**RE: UHOPA-20-012 and ZAC20-016  
1107 Main Street West, Hamilton (Ward) 1  
Non-compliance of proposed development with established Urban Design Policies  
and Guidelines of the City of Hamilton and inconsistent with the PPS (2020)  
Quantitative Comparison of proposed development with the Good Shepherd Square**

# City of Hamilton Design Review Panel Meeting Summary – January 14<sup>th</sup> 2021

### 1107 Main Street West

**1 SITE PLAN**

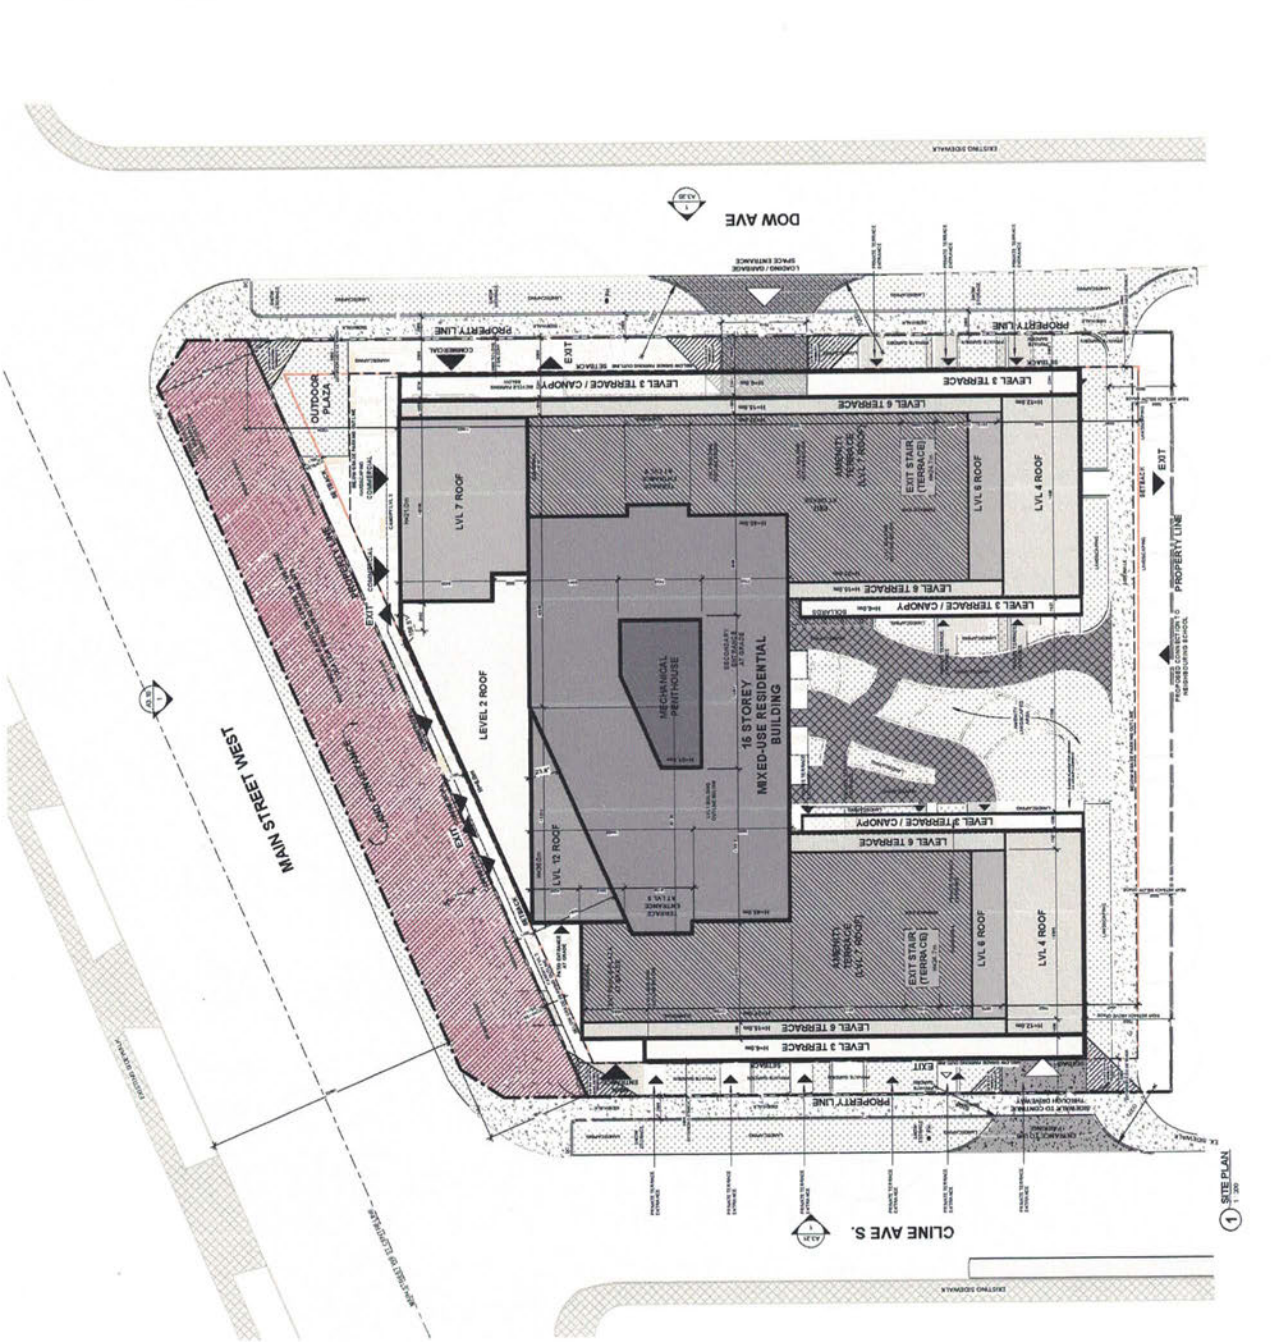
In contrast, the proposed development of the Applicant as indicated on its site plan, is that the project will only have a setback of 3.0 metres on the two side streets, which is only 50% of the required distance in the zoning by-law and only 50% of the setback provided by the Good Shepherd Square throughout its project. The reduced setback distance dramatically impacts on the character of the neighbourhood and is an incompatible transition to the existing residential houses on Dow Avenue and Cline Avenue South. It also results in an increase in the built form and the impermeable percentage of the building envelope at the expense of natural permeable landscaping at ground level and by a severe reduction of the subwatershed recharge which is essential for the growth and maintenance of the urban forest within the neighbourhood.

For the proposed development the front yard setback required in the TOC1 Zoning By-law is set at 4.5 metres from Main Street West, but it appears from the site plan that the Applicant is proposing only a 1.7 metre setback. Furthermore, the Applicant's response to the requirement to avoid the "street canyon effect" was only to reply that there would be no direct sunlight on sidewalks of Main Street West if the developer built one continuous built form of eight storeys in height. This demonstrates that the Applicant considers that it can utilize an "as of right" to totally disregard this important City of Hamilton design principle.

The Good Shepherd Square rear yard setback in terms of metres is not available to me, however, these lands appear to have a fully landscaped buffer zone as its rear yard setback which is greater than the 7.5 metres. The Applicant's proposed site plan for the rear yard of the southerly boundary of the development has a rear yard setback of 7.5 metres above grade, but with the exceptionally large underground parking garage, the setback is only 3.0 metres below grade.

The Applicant's proposed step-backs, however, in direct contrast to those of the Good Shepherd Square, are extremely shallow in depth as they only commence while still within the setback clearance distance of 6.0 metres. This results in some of the upper levels of the proposed building still being closer than 6.0 metres to the property line, and this creates a vastly inferior transition into the neighbourhood. Even with the Applicant's proposed setback and step-backs much of the buildings and the wings are closer to the property line than any portion of the buildings located at the Good Shepherd Square, which indicates the extreme shortcomings of the Applicant's urban design form, when compared with a "good and modern" urban design for appropriate levels of intensification on a higher order traffic corridor and while still meeting government established density targets.

In contrast the Applicant's proposed development has a **15-storey building**, with an additional **two-storey rooftop mechanical penthouse**, and two buildings or wings that are attached to the podium and extending into the neighbourhood along Dow Avenue and Cline Avenue South. For the two additional buildings or wings the height is 7 storeys, with a small shallow depth step-back beginning with the third storey, and rising up the fourth, fifth and sixth storeys, and then another small shallow step-back for the seventh and eighth storeys on Dow Avenue and Cline

Avenue South. Only for the rear yard do the wings have a **height of four storeys** with a step-back from the fourth storey of 7.45 metres to the sixth storey, and a final step-back of 2.67 metres to the seventh storey.

If one calculates the amount of setback area that the Applicant has requested by way of variance to be relieved from adhering to the TOC1 zoning, it can be estimated that **414.14 square metres or 4,456 square feet** of critical setback area are "absent" from the proposed development, whereas Good Shepherd Square provided 100% of the setback and had this setback area landscaped.

- 1) Frontage on Main Street West which is not in compliance is approximately **38.597** metres and it is **2.8** metres closer to Main Street West than the TOC1 zoning allows. Total absent area is **108.07 square metres**.

- 2) Frontage on Dow Avenue which is not in compliance is approximately **57.690** metres and it is **3.0** metres closer to Dow Avenue than the TOC1 zoning allows. Total absent area is **173.07 square metres**.

- 3) Frontage on Cline Avenue South which is not in compliance is approximately **44.334** metres and it is 3.0 metres closer to Cline Avenue South than the TOC1 zoning allows. Total absent area is **133.0 square metres**.
